MONITORING YEAR 5 ANNUAL REPORT

BUCKWATER MITIGATION SITE

RE: DMS Comments on the MY5 Report
Buckwater, Project ID #97084, DMS Contract 6829

Figure 1. Integrated Current Condition Plan View
 Buckwater Mitigation Site
 DMS Project No. 97084
 Monitoring Year 5 - 2023

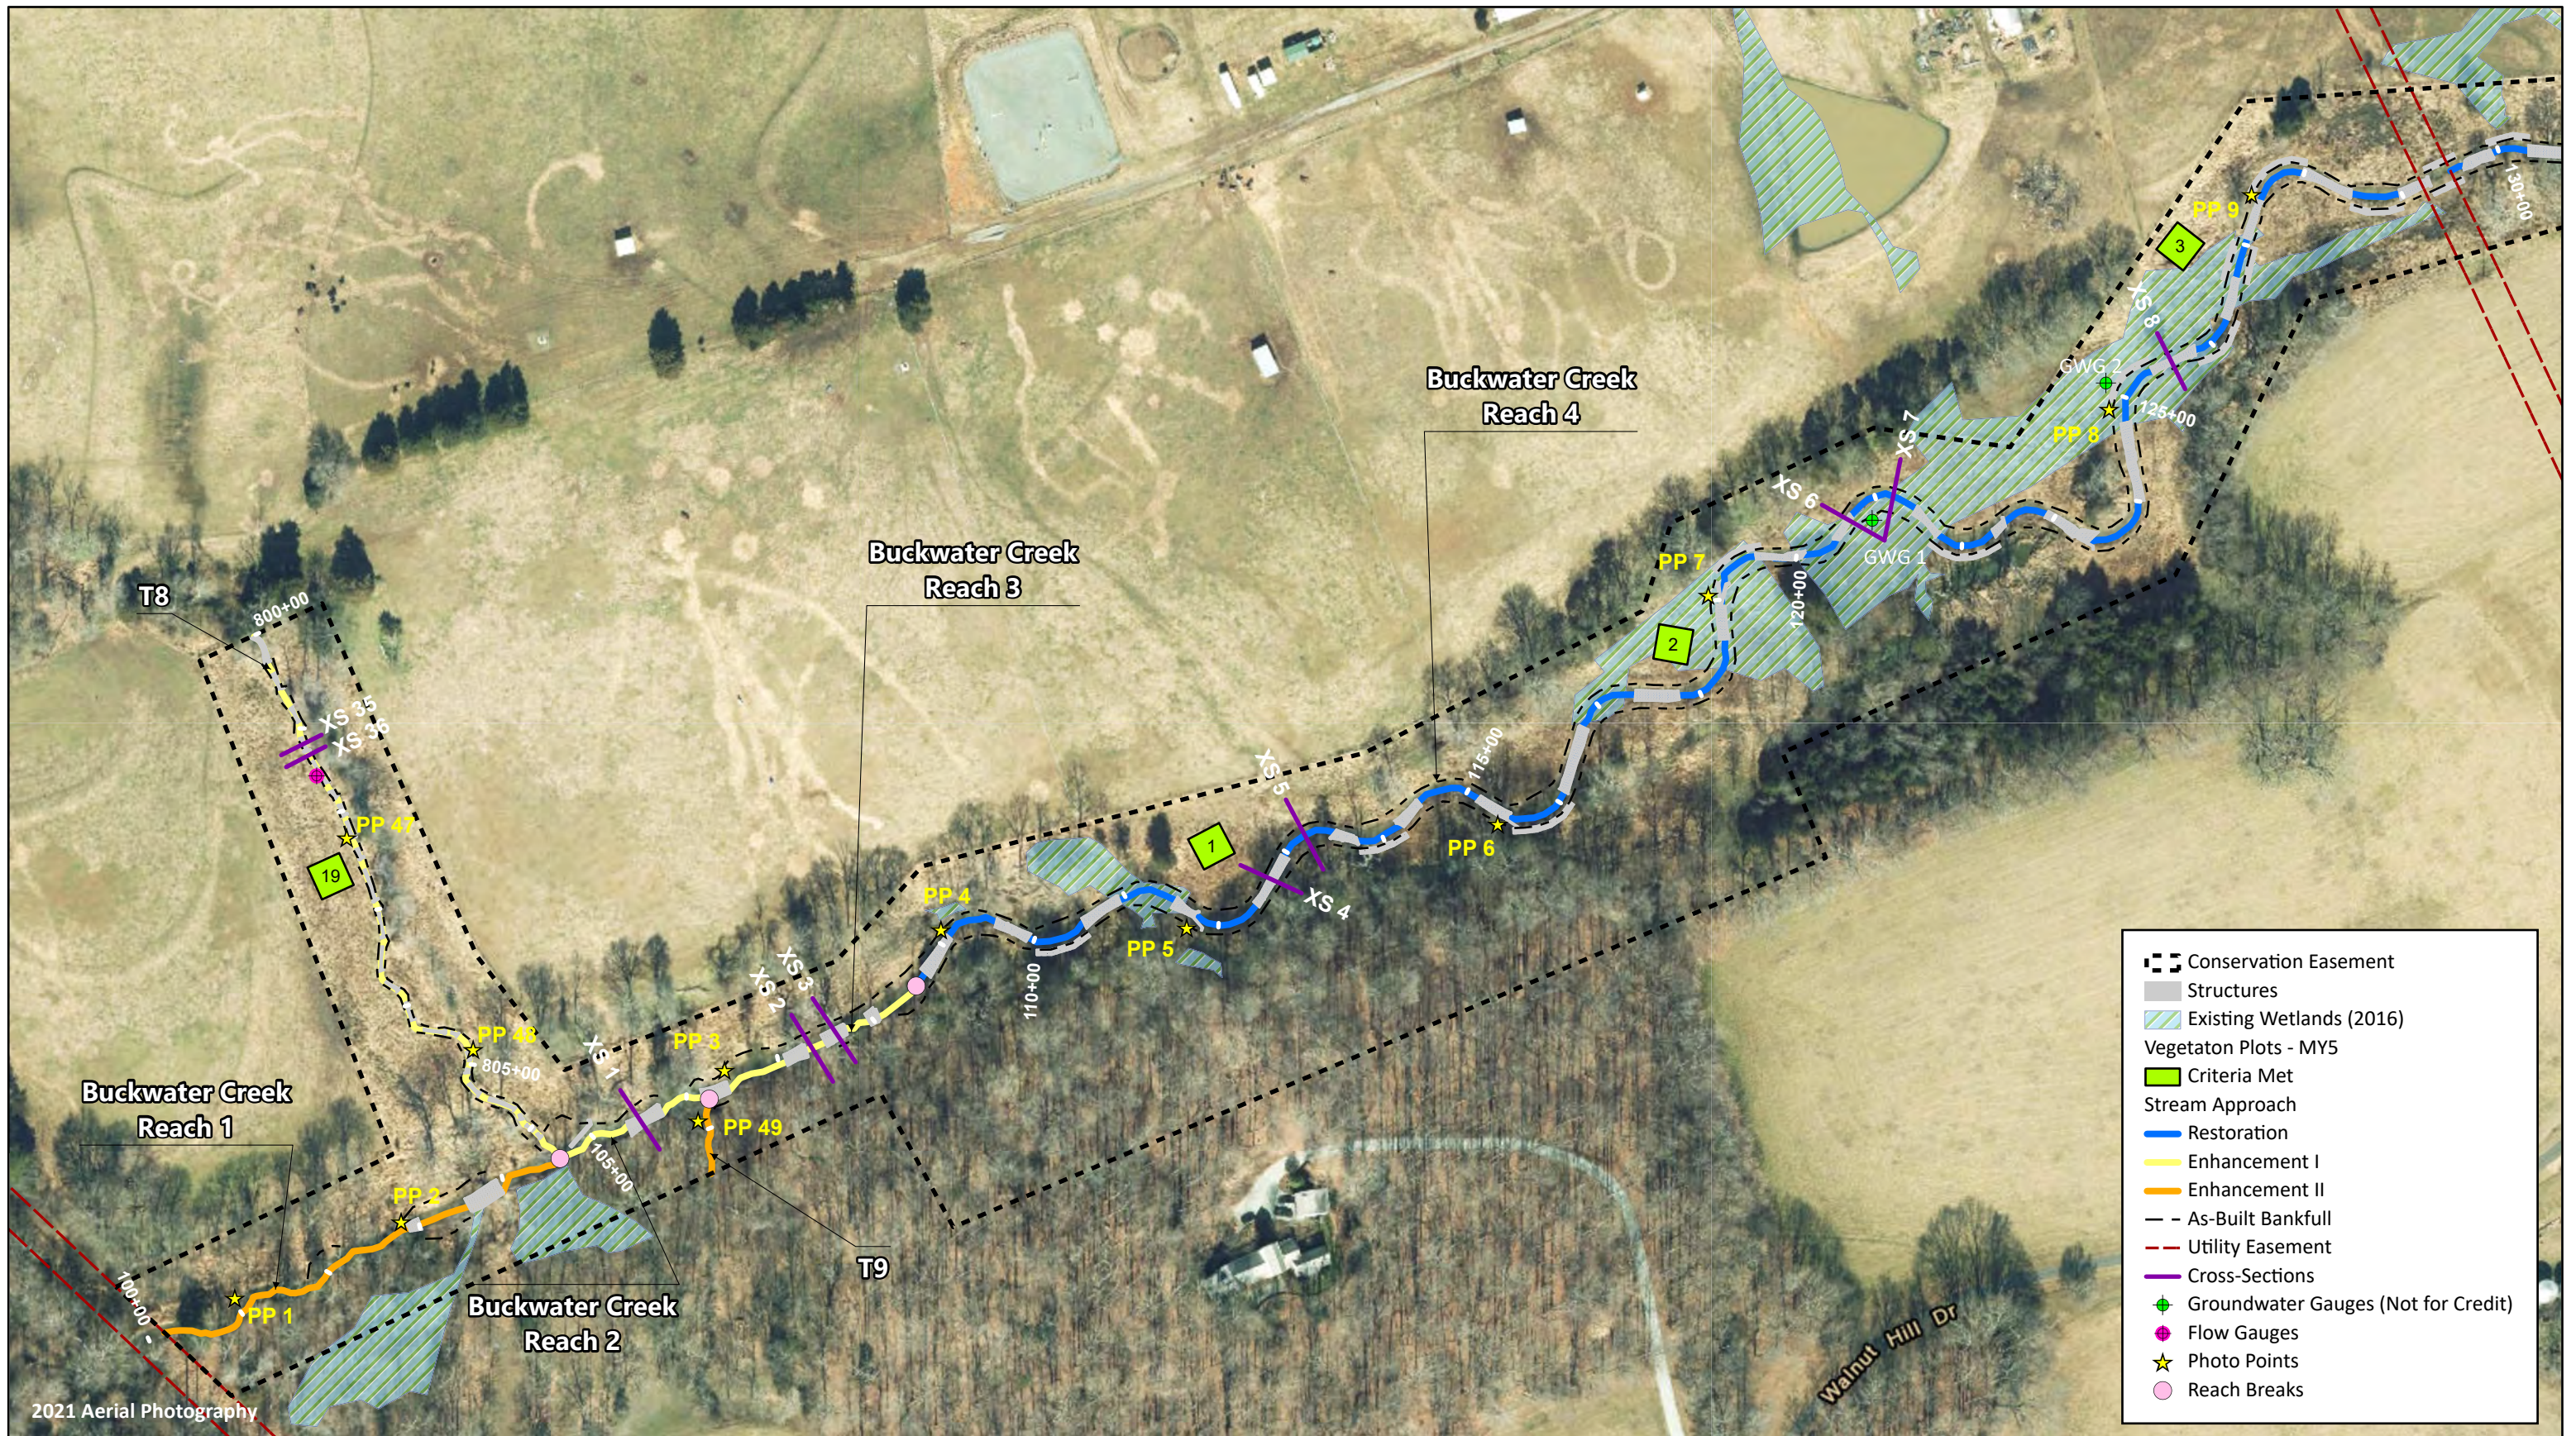
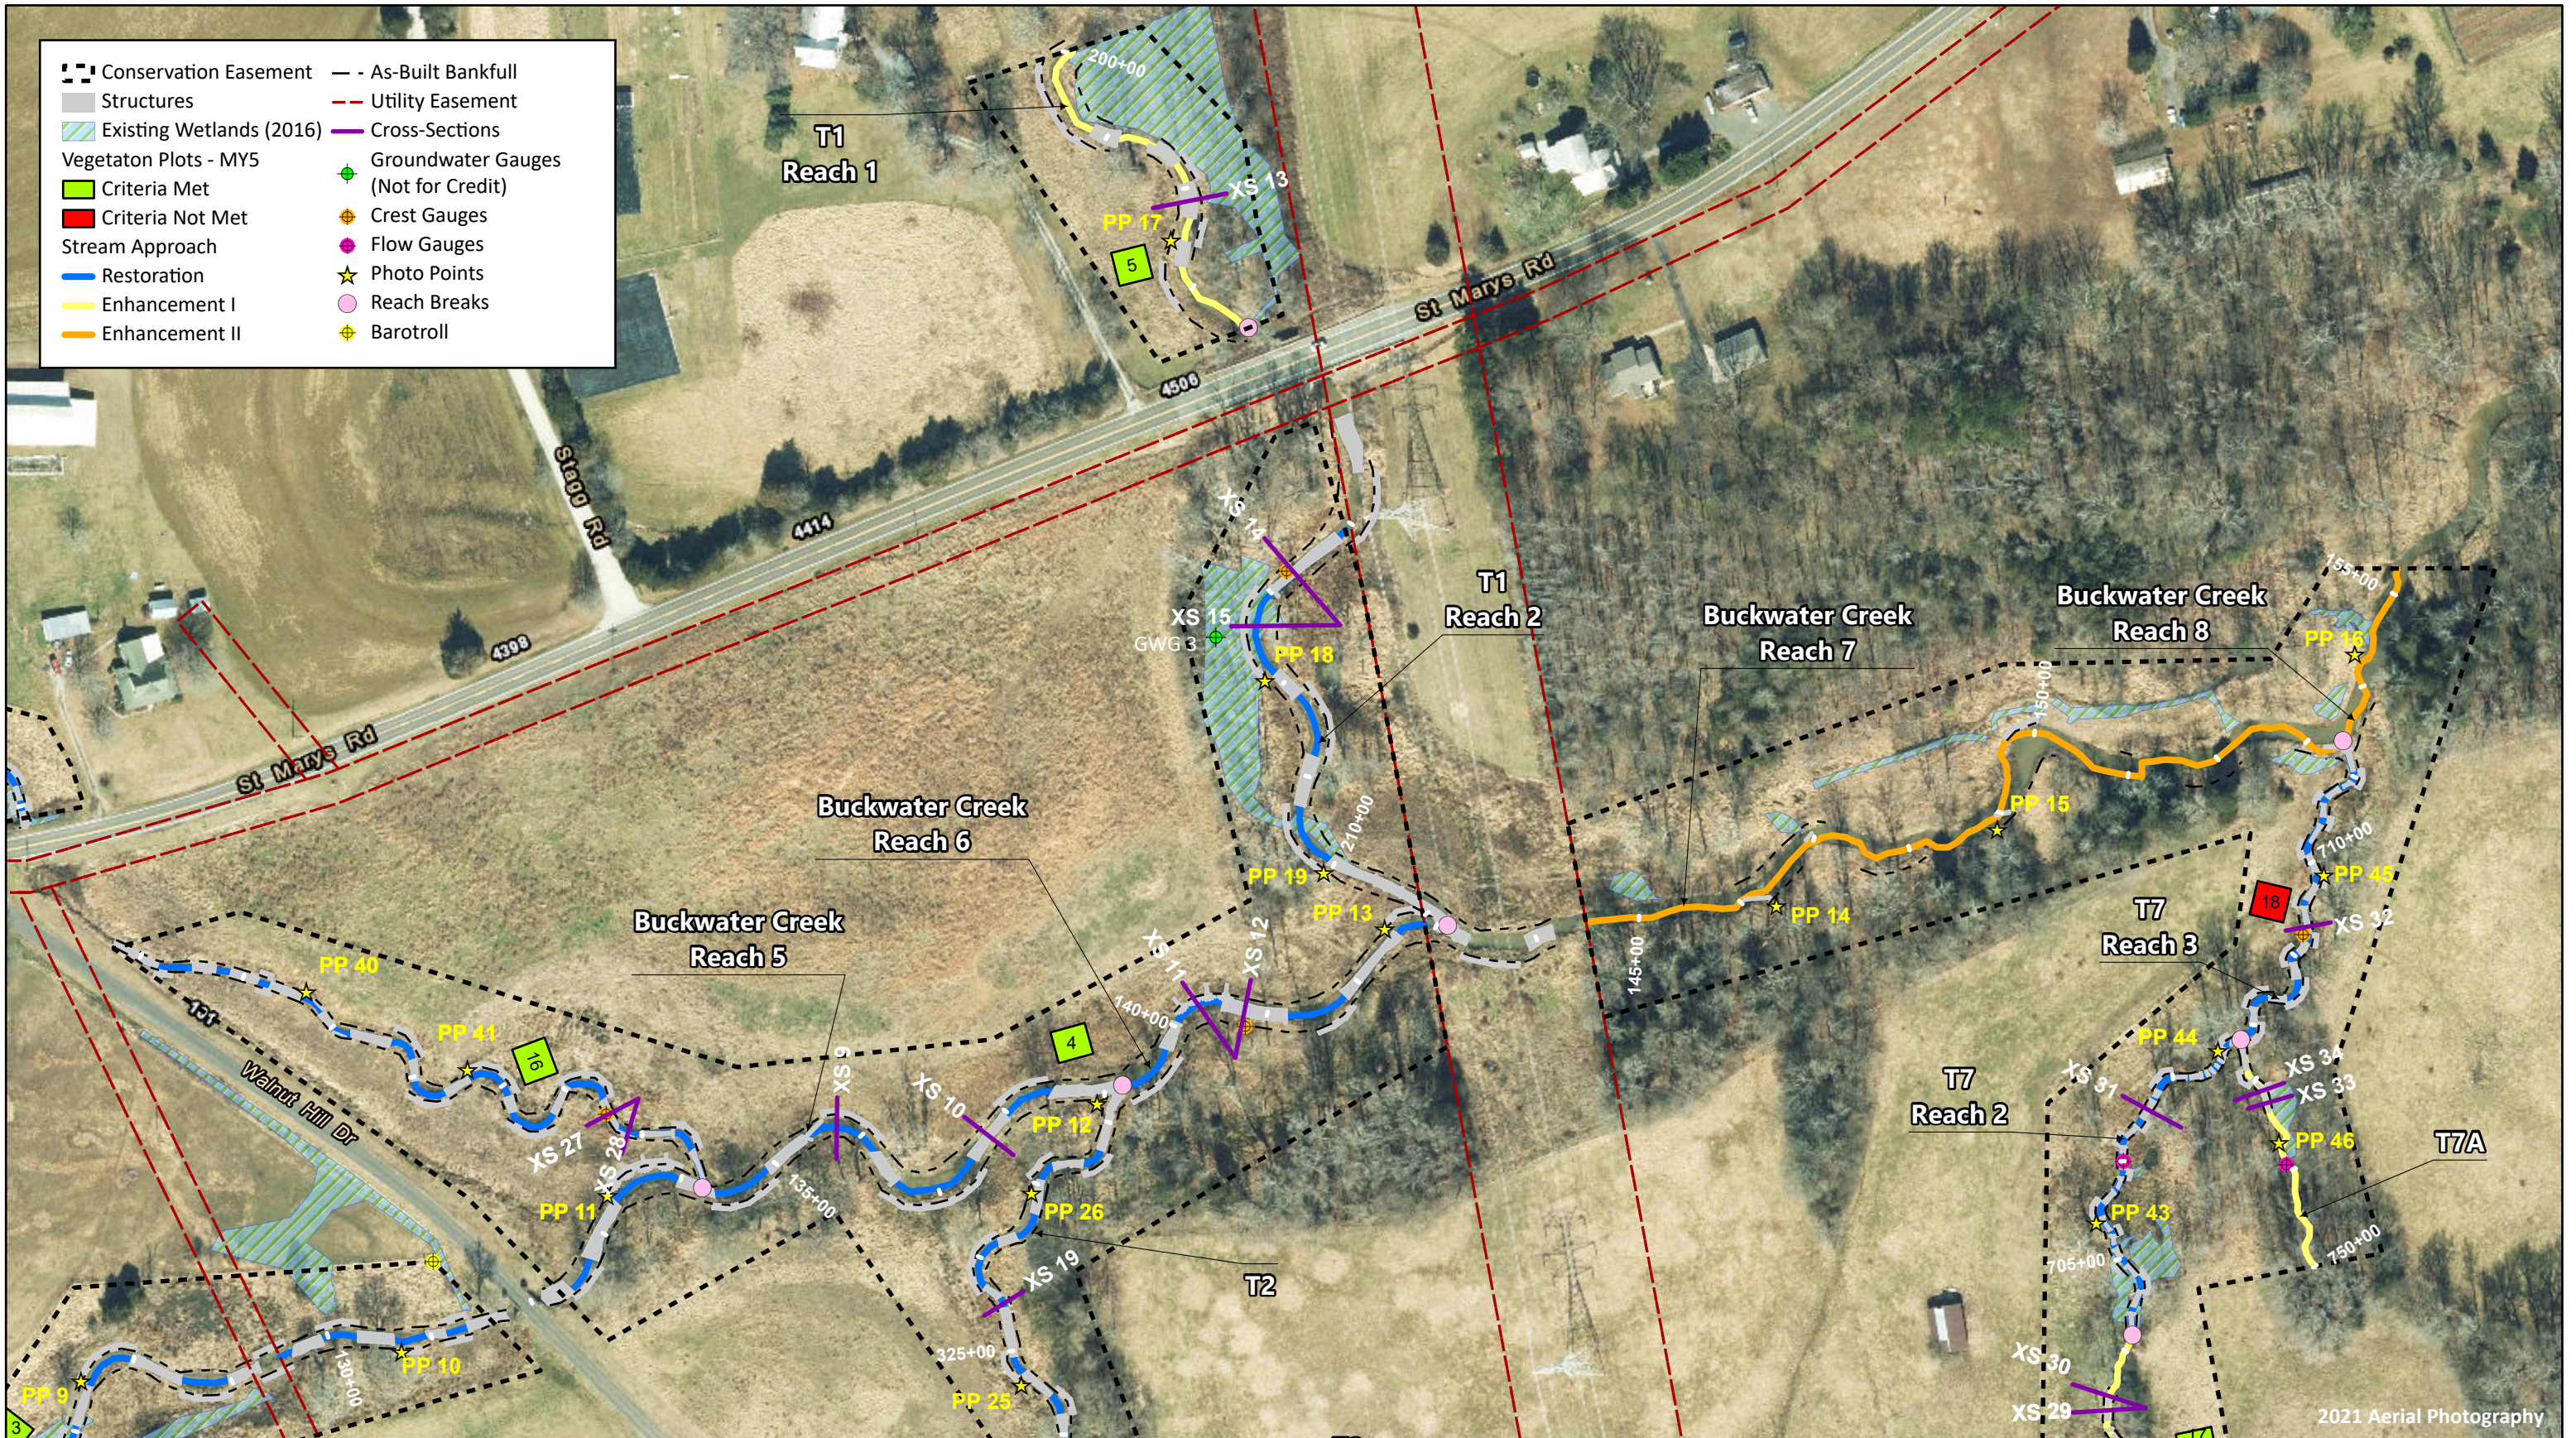
3. Figure 1b – a couple of the veg plots are not labeled, or the label is offset so it is difficult to see.

Response: Figure 1b has been updated to clearly show the veg plot labels.
